***Request for Contribution for Refining  
the Seamless Redundancy Concept  
Presented in San Diego***

*(Version Date: September 4, 2012)*

**Markus Jochim, General Motors Research & Development  
Oliver Kleineberg, Hirschmann Automation & Control**

Comment 1: “Redundancy management in bridge (Time constraints in fast path)”

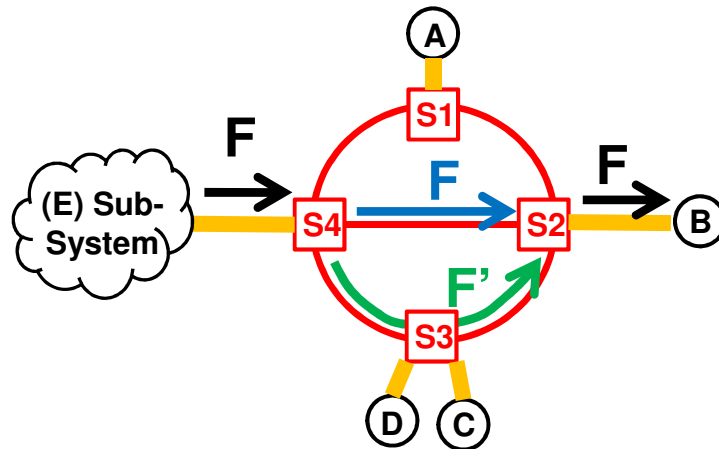
According to slide 25 of [\[1\]](#), the bridge executes the redundancy management function that eliminates duplicates. This is difficult since the function would need to be executed in the fast path and in the fast path there is probably not enough time to execute the function. Evaluate the option to execute the redundancy management function in the listener instead!

- If the listener executes the redundancy management function, both messages F and F' have to be forwarded from S2 to B. The link may become be a bandwidth bottleneck.
- Depending on the complexity of the network and the number of redundant paths, the bottleneck problem may get worse and network design flexibility can suffer.
- Even if integrating redundancy management functions into the bridges is challenging, lightweight duplication elimination techniques (like a multiple sliding /drop window algorithm) could be used – especially if seamless operation is only considered for scheduled traffic

We believe it is worth to start out by collect some opinions on which solutions within bridges might work.

## *Response to comment #3 (Slide 1/2)*

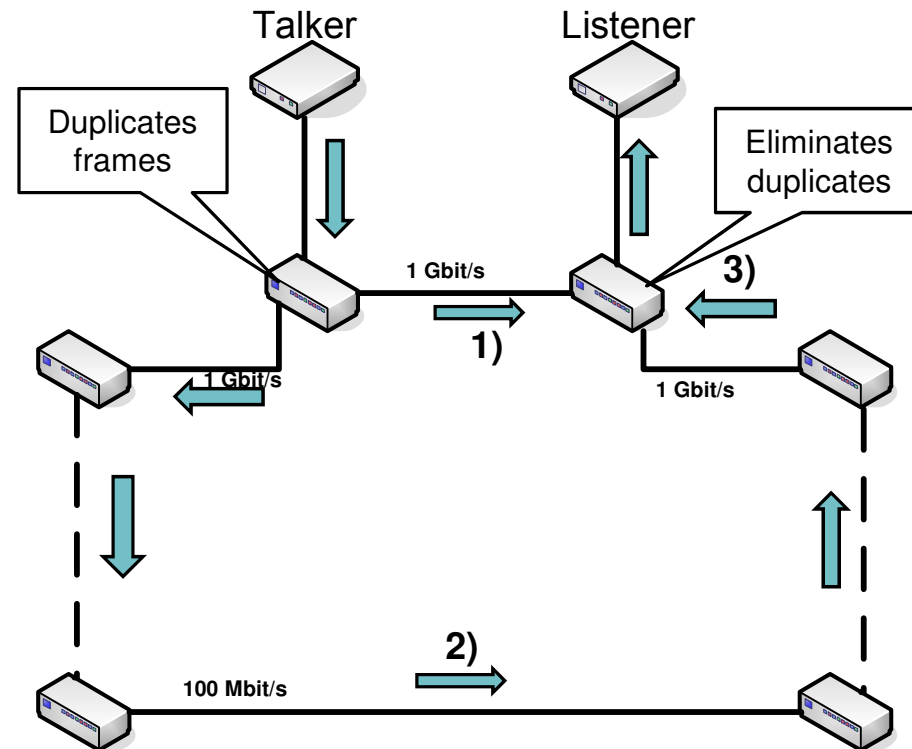
a) In the diagram on slide 24 of [\[1\]](#) the frames F and F' may arrive at S2 at different points in time. How do we address this problem especially in scenarios where the frames arrival times may differ quite a bit (e.g. because the links in the topology are operated at different speeds).

- One possible constraint introduced could be the restriction of only allowing redundant paths to have the same link speeds.
- There will always be a certain difference between the frames from F and F'... the redundancy management (in this case the duplicate elimination procedure) must be designed in a way that it can detect duplicates within the worst case time difference between F and F'

If we assume that differing link speeds on different paths, in respect to redundancy, result in different max. latency, the problem is reduced to handling the time difference between the arrival of F and F'. Bandwidth implications will be handled by SRP.
